GeoSolve Ref: 240480.03
3 December 2025

Otago Regional Council
70 Stafford Street (Phillip Laing House)
Dunedin 9016

Geotechnical Engineering Assessment Memo Bendigo-Ophir Gold Project Fast-Track Application Assessment

Figure 2: Unstable zone around abandoned mines (https://www.worksafe.wa.gov.au/system/files/documents/2025-02/MSH_G_SafetyBundWallsAroundAbandonedMines.pdf)

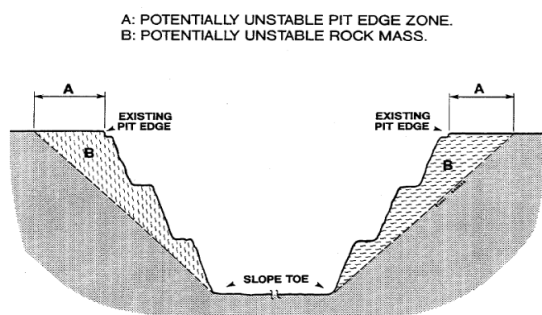
We understand that backfilling is not proposed for the RAS and SRX pits; these are instead to remain as open pits with associated pit lakes in perpetuity. There will therefore remain an unstable zone around these pit margins on closure and bunding is proposed to prohibit public access. The extract below from Western Australia guidance illustrates this concept.

1. Designate an exclusion zone around the pit to prevent public access. The extent of the exclusion zone shall be determined based on residual stability risks and safety considerations and must be approved by the Consent Authority.
2. Construct and maintain physical barriers (e.g. bunds) and install appropriate signage to restrict entry and warn of hazards.

Figure 3: Stability Analysis Extract from B.28 Report (p46 & p47), Plan extract from C.02

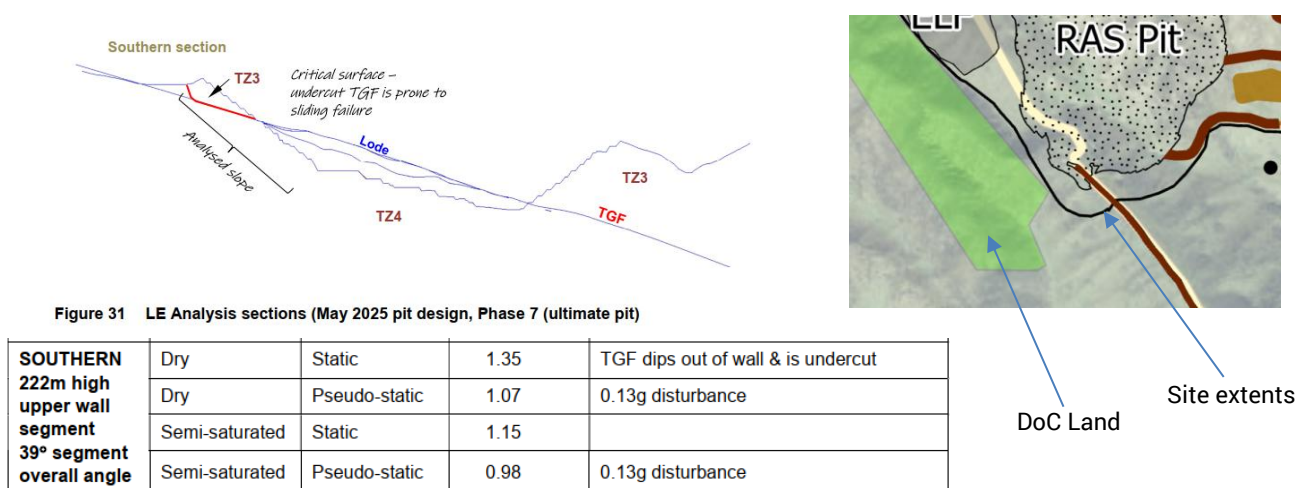
However, it is important that any land outside the mine site is not destabilised by the mining operations as public access may be possible in these areas (i.e. the land bordering the southwest of the CIT pit and the RAS pit is public conservation land). Typically, a long-term factor of safety (FoS) of at least 1.5 under static loading conditions would be required within land accessible to the public and it appears from the stability analysis of the RAS pit when at full depth that this may not be achieved.

Based on the basic section and the analysis results there is a risk that these typical target factors of safety are not achieved in public land, and as noted this analysis is preliminary. The section above would also suggest there is the potential for sliding along the TGF to extend beyond the site boundary, although likely not onto Department of Conservation (DoC) land.

The other issue is that as the RAS pit will not be backfilled, an exclusion zone around the pit will need to be established on abandonment as noted above to permanently restrict the public from approaching the pit edge. Typically, this involves the construction of a rock bund (generally 2 m high by 5 m wide) and this exclusion zone could encroach on DoC land, although buttressing of the pits walls could mitigate this issue on closure.

The consent holder must ensure that the stability of ground outside the project site boundary is not adversely affected by the construction or operation of any of the deep mining pits.

1. A minimum FoS of 1.5 shall be maintained under static loading for all ground outside the site boundary, unless an alternative FoS is agreed in writing by the Consent Authority.
2. Prior to excavation, the consent holder shall provide a geotechnical stability assessment prepared by a suitably qualified and experienced practitioner. The assessment must:
 - Model potential failure surfaces and assess FoS for areas outside the site boundary.
 - Identify any mitigation measures or monitoring required to maintain compliance.
3. All stability assessments and monitoring reports shall be prepared by a suitably qualified chartered geotechnical or mining engineer.

Figure 4: Cross Section Through TSF on Closure

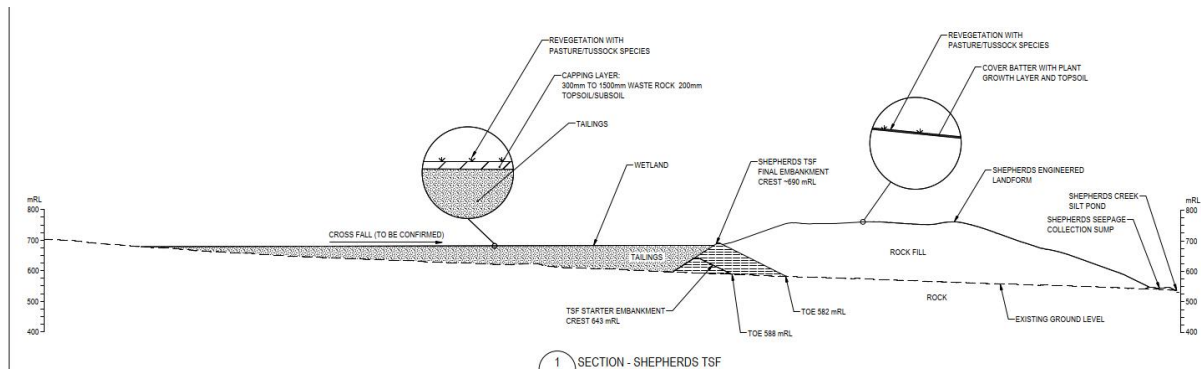
One key point is that the dam will be buttressed by one of the engineering landforms as shown on the section below. We understand this buttress will be constructed from waste rock from the mine pit and will be constructed concurrently with the dam. The designer has not accounted for the additional stability provided by the waste rock buttress in their design which is conservative.

The buttress will result in a significant improvement in the dam stability, which in our view means that post-closure there is no credible risk of dam failure.

Figure 5 – Landslides that Coincide with the RAS Pit

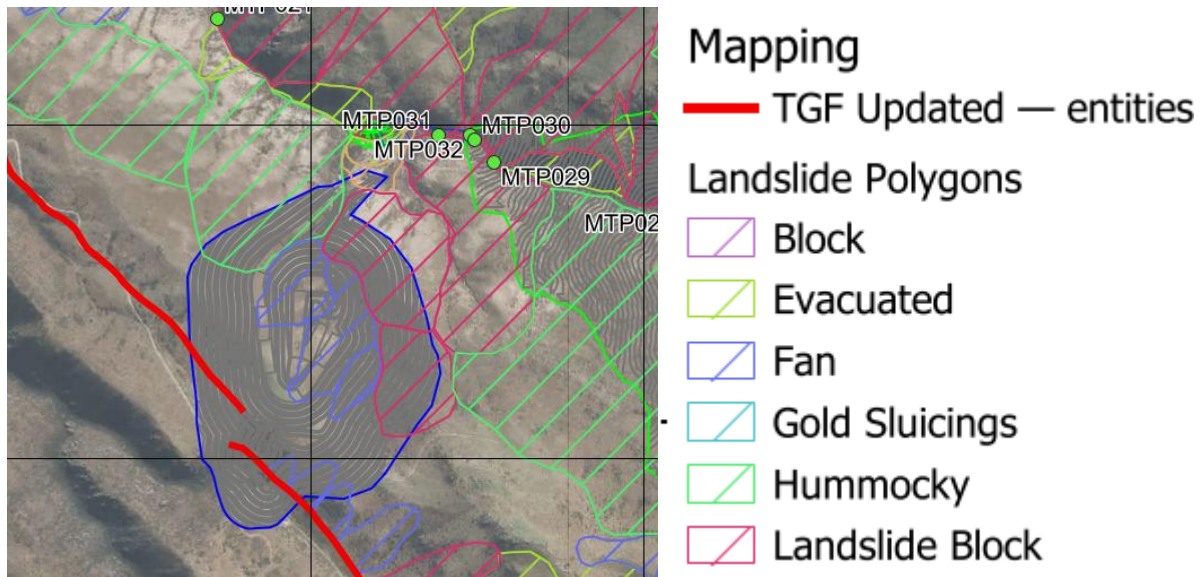
As can be seen in Figure 5, there are two mapped landslides that coincide with the RAS pit. These mapped slides were not immediately apparent on site due to the viewing angle, but given the topography are likely to be trending in a northerly direction. It appears that a significant portion of these landslides will be excavated out as part of the mining and therefore the presence of the slides is something that will need to be considered during the initial excavation works by the applicant. As the slides are entirely within the mining site, there will be no external effects.

Figure 6: Extract from B.28 showing portal cross section

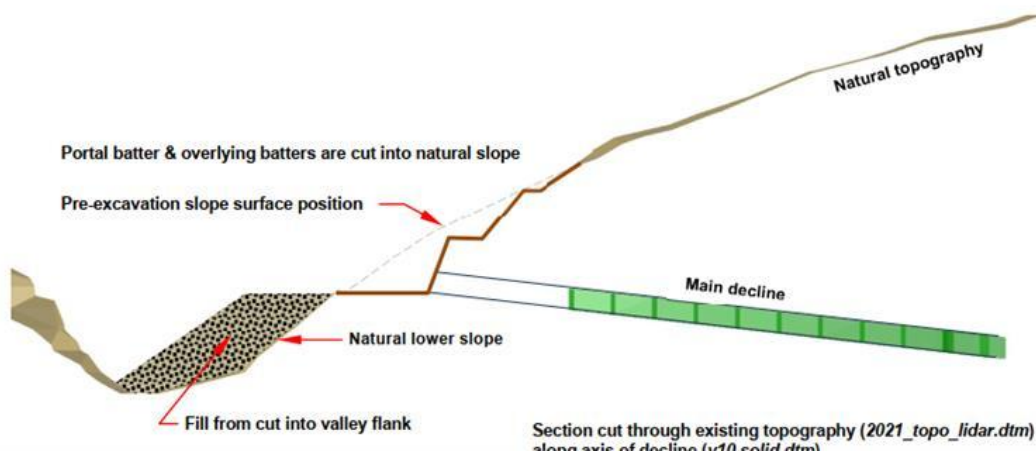
The portal for the underground mining will be constructed at the toe of an ancient schist landslide. The excavation of the portal has the potential to reduce the stability of the landslide, although this may be offset by placement of the spoil within the valley, hence the overall impact may be neutral. As part of the detailed design of the portal this issue should be considered.

The applicant will need to consider these landslides as part of their detailed design of the various elements affected.
